Report to the Council

Agenda item 6.5

Planning Application TP-2008-554/B North Melbourne Recreation Reserve, 204-206 Arden Street, North Melbourne

DELEGATED PLANNING APPLICATION REPORT

E02 EAST ELEVATION
SCALE 1:100

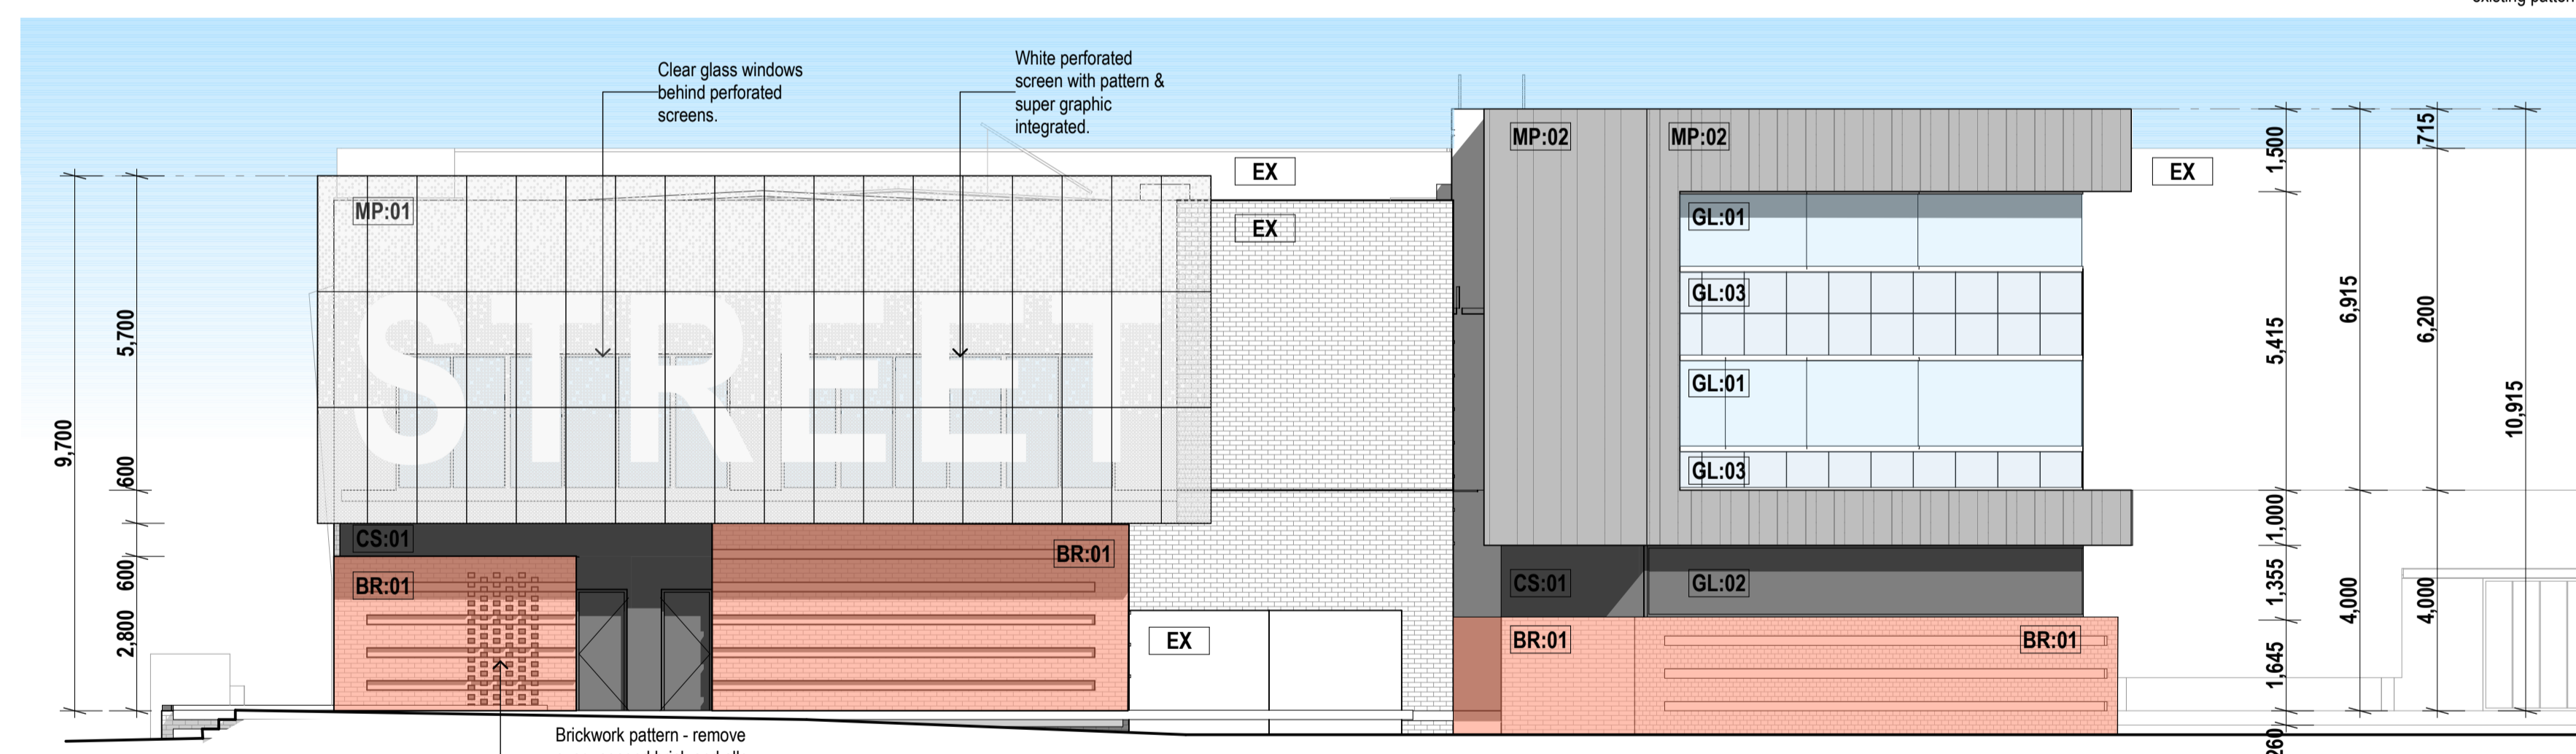
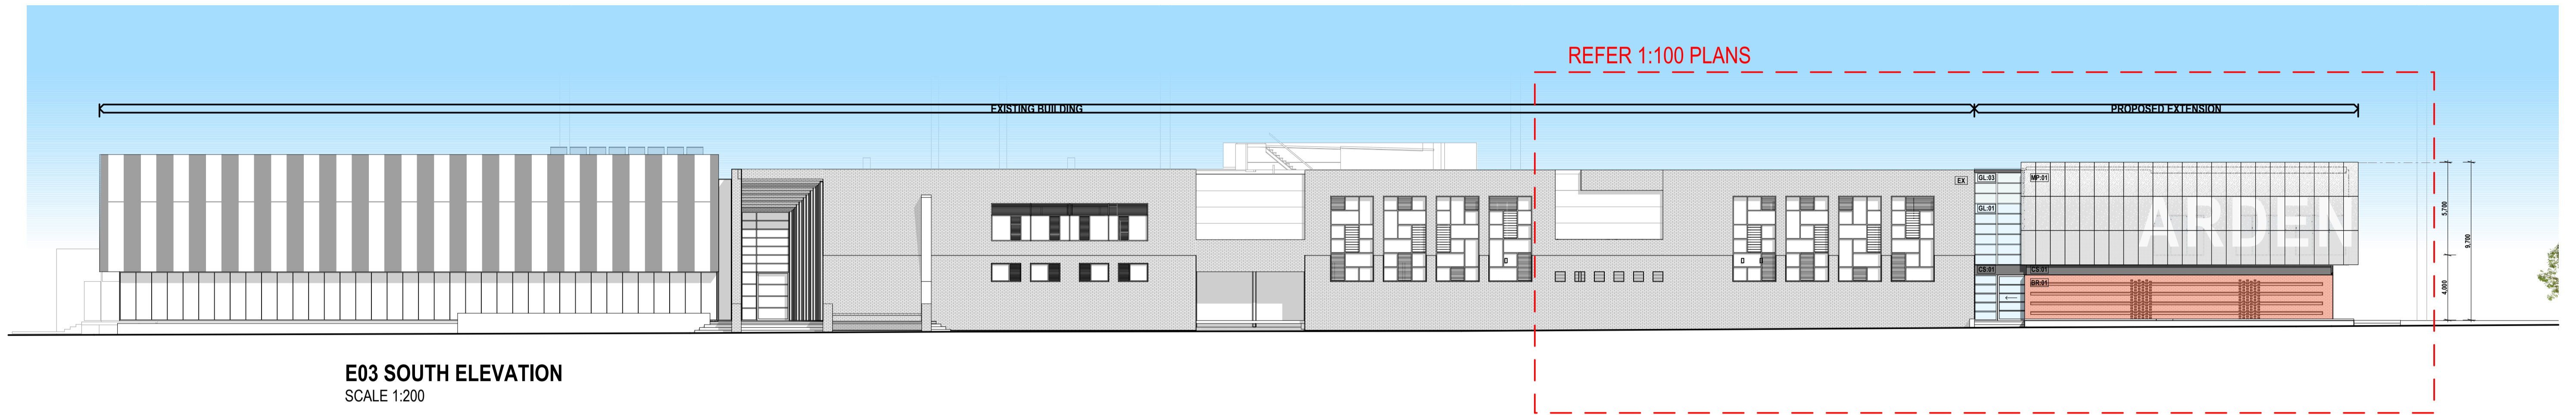
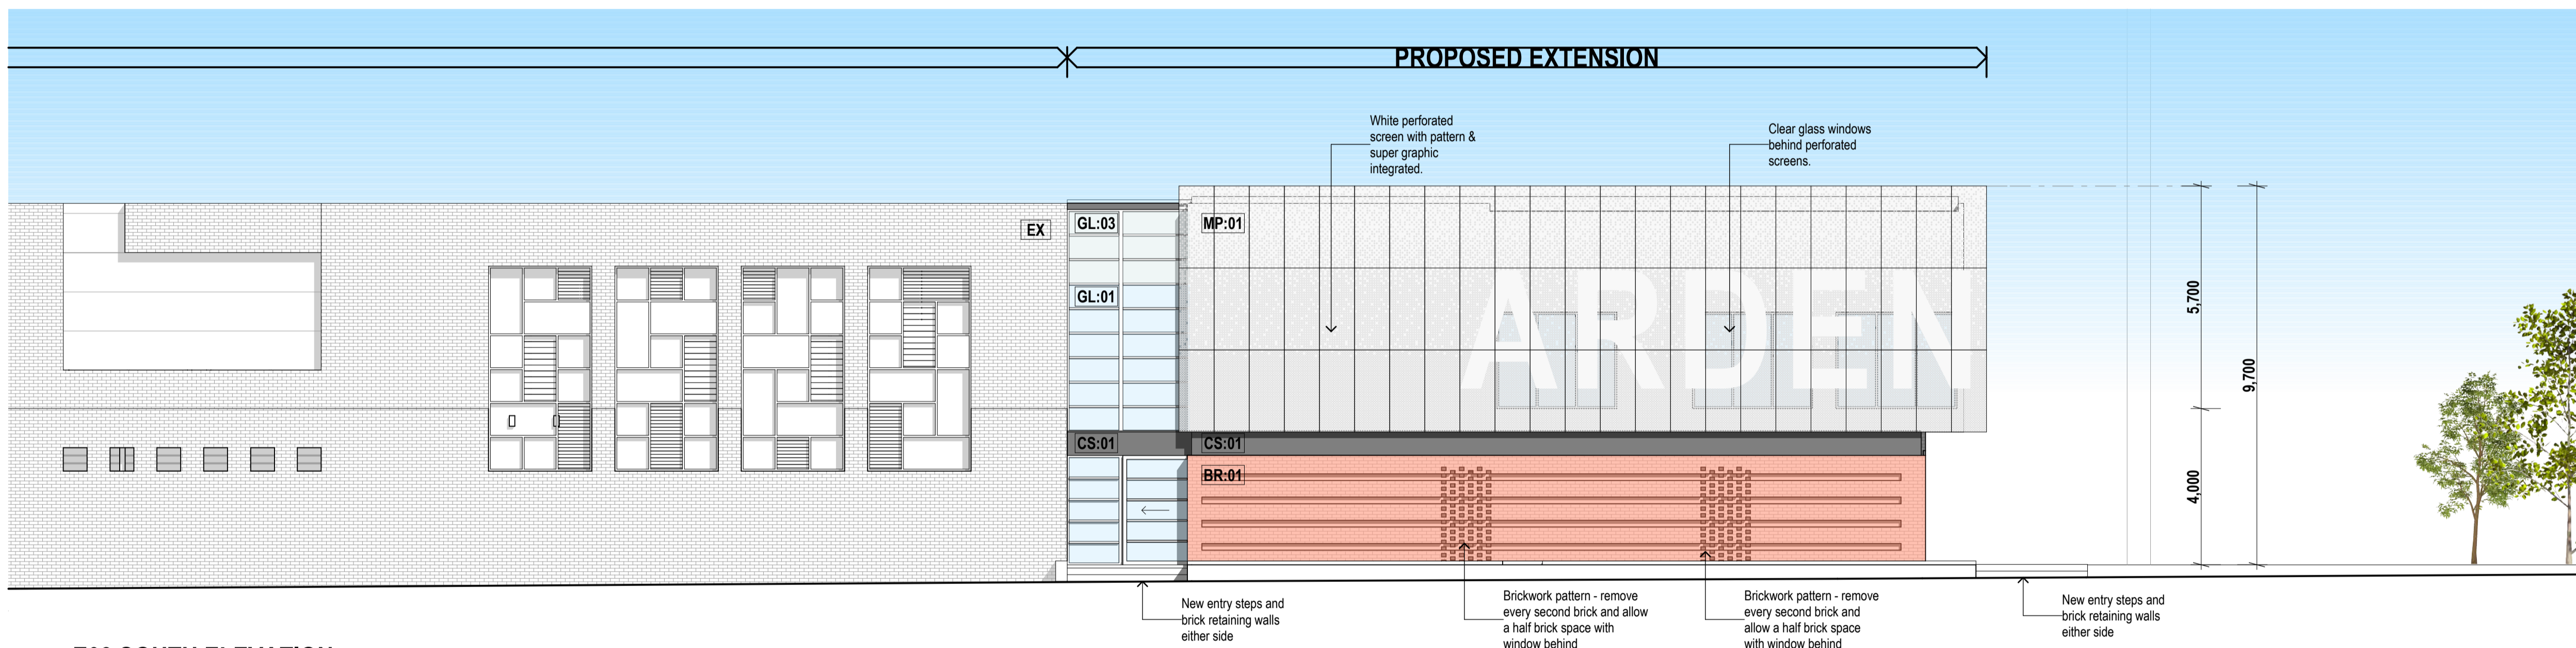
- Area of the open brick perforations to the ground floor Arden Street frontage to be increased to improve visual interest and light spill at night as well as activation.
- Outer frame of the coaches box to be clad in 'banded light colour' cladding as used in the current building.
- Provide a landscape plan, in particular to demonstrate soft landscaping to the pedestrian presentation to Arden Street.

extend the existing facility along the frontage. It includes a new entry to Arden Street but, due to the internal planning with change rooms at ground level, there is minimal opportunity for additional ground floor windows but there are first floor windows with a perforated screen to allow for a degree of street surveillance. Additional perforated bricks will be required via condition if a permit is to issue as per Urban Design advice.

- b) Details of the scoreboard**
- c) Area of the open brick perforations to the ground floor Arden Street frontage to be increased to improve visual interest and light spill at night.**
- d) Outer frame of the coaches box to be revised to complement cladding used in the current building.**
- e) Provide a landscape plan, in particular to demonstrate soft landscaping to the pedestrian presentation to Arden Street.**
